Windshield Wiper Motor Gear**2010-2011 VN, VAH, VHD****RVXX1304, Windshield Wiper Motor Gear****(December 2013)**

VOLVO Trucks North America has determined that on Certain 2011-2012 Volvo VAH, VHD, VNL, and VNM model vehicles, manufactured during the periods of February 1, 2010 through September 30, 2010 and June 1, 2011 through November 30, 2011, the wiper motor drive gear may prematurely fail which can result in the wipers not working.

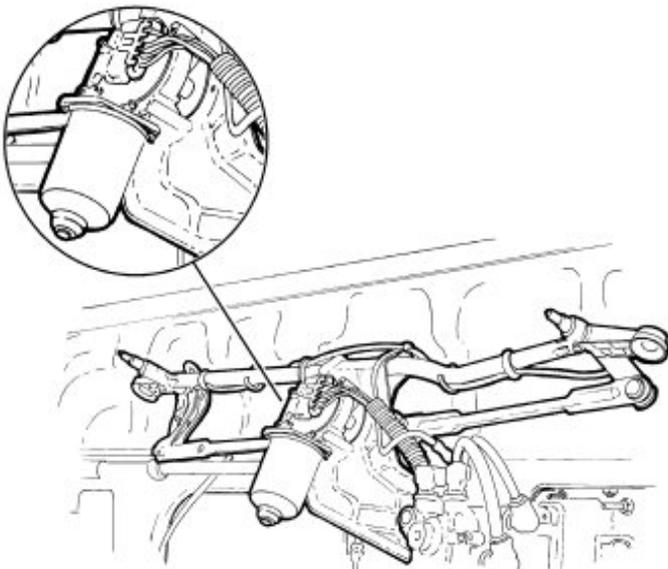
5. Remove the nut from the linkage arm and push the wiper arm from the shaft.
6. To allow access to the wiper motor mounting bolts, push the linkage arm away from the area where the windshield wiper motor is mounted. Remove the three bolts to remove the motor.
7. Apply one drop of Loctite 242 (or equivalent) to new wiper mounting bolt threads. Mount the new wiper motor to the bracket. Start all three bolts before tightening.
8. Torque the bolts securing the wiper motor to 11.3 +/- 1.1 Nm (100 +/-10 in-lb).
9. Align the wiper linkage to the motor. Install the new nut on the shaft. Torque the fastener to 22.5 +/- 2.25 Nm (200 +/- 20 in-lb).
10. Connect the electrical connector to the windshield wiper motor.
